Ljubljana (Slovenia) No 1643

The works of Jože Plečnik in Ljubljana – Human Centred Urban Design

2 Issues raised

Map showing the revised boundaries of the property and of the proposed buffer zone (February 2022)

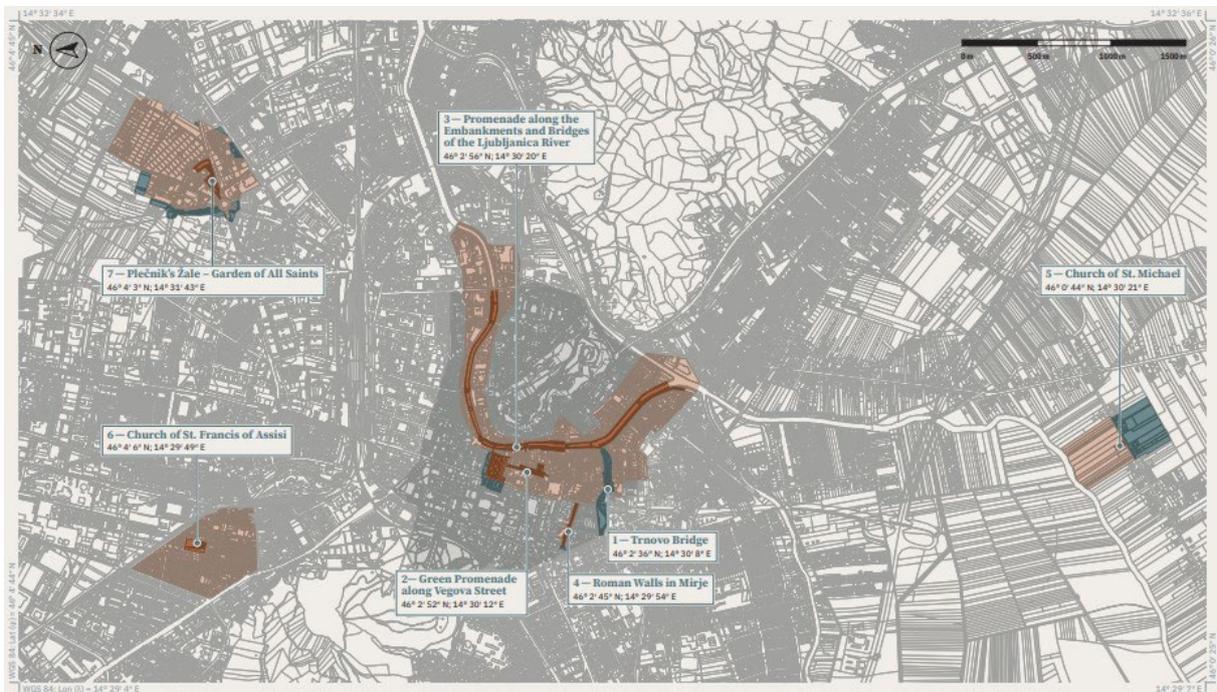
The proposal involves a minimal boundary expansion of the property's component part 4, the Roman Walls in Mirje. Changes to the buffer zones are proposed for five component parts: Trnovo Bridge, Green Promenade along Vegova Street, Roman Walls in Mirje, Church of St. Michael, and Plečnik's Žale – Garden of All Saints. Lastly, the addition of a wider buffer zone in the city centre is proposed. The proposal follows the changes to the legal protection that entered into force in May 2021, namely the Ordinance amending the Ordinance designating the work of the architect Jože Plečnik in Ljubljana as a cultural monument of national importance (Official Gazette of the Republic of Slovenia, No. 74/21) of the year 2021.

The minor change to component part 4 adjusts the property boundary north of the pyramid to follow the existing parcel and adds a small rounded parcel at the western corner of the Roman Walls. The component part is thereby slightly enlarged from 0.720 to 0.726 ha as per article 4 of the 2021 Ordinance.

ICOMOS considers that this revision of the property boundary is necessary and contributes to reinforcing the conditions of integrity of the property and hence maintaining its Outstanding Universal Value.

Trnovo Bridge was defined as a separate component part and assigned its own buffer zone as per article 5 of the 2021 Ordinance within the joint buffer zone of component parts 1, 2, 3 and 4. The buffer zone of Trnovo Bridge now encompasses the entire monument of the Gradaščica area which constitutes one of the transversal axes. The joint buffer was enlarged with the addition of the western part of this area.

The buffer zone of component part 2 was extended to the north and west as per article 2 of the 2021 Ordinance. It now includes a series of buildings running from and including the Ursuline Church to the Šubič Grammar School, the crossroads of Slovenska Road and Šubičeva Street in the northwest corner of Zvezda Park, and a series of buildings along the northern side of Zvezda Park from the Kazina Palace to Wolfova Street. These extensions respond to requests from ICOMOS in its Interim Report of December 2020.

The same is the case for the extension of the buffer zone on the western extremities of component part 4 as per article 4 of the 2021 Ordinance. It was extended to the crossroads of Groharjeva and Jamova Streets. The eastern extremities and the southern setting of the Roman Walls in Mirje are protected under the new wider buffer zone of the historic city centre. Nevertheless, ICOMOS recommends that in the future the buffer zone be complemented, through a minor boundary modification request, with the adjacent stretch of Barjanska Street up to Aškerčeva Street as well as extended onto the plots located south of the traffic artery of Mirje on the entire length of the Roman Walls.

Likewise, in response to ICOMOS' requests, the buffer zone of component part 5 was extended to the southeast across the road in front of the Church of St. Michael and by parcels on the Ljubljana Marshes. The buffer zone of the component part was thereby enlarged from 12.984 ha to 22.450 ha as per article 1 of the 2021 Ordinance.

The expanded and additional buffer zones include the immediate and wider setting of Plečnik's interventions, encompass views or include other areas that are functionally or otherwise important for the protection of the property. ICOMOS considers that these revisions of the buffer zone boundaries and the pertinent legislation, which include stipulations for Heritage Impact Assessments (article 8 of the 2021 Ordinance), effectively adds to protecting the property from development pressures.

The proposed minor boundary modification coincides with the additional information provided on the matter to ICOMOS in February 2021. In summary, ICOMOS considers that the proposed minor boundary modification enhances the property's integrity, complies with the request of Decision 44COM 8B.45 (§ 4.a and f) and should therefore be approved.

ICOMOS recommends that the proposed minor modification to the boundary of The works of Jože Plečnik in Ljubljana – Human Centred Urban Design, Slovenia, be **approved**.

ICOMOS recommends that the proposed minor modification to the boundaries of the buffer zones for The works of Jože Plečnik in Ljubljana – Human Centred Urban Design, Slovenia, be **approved**.
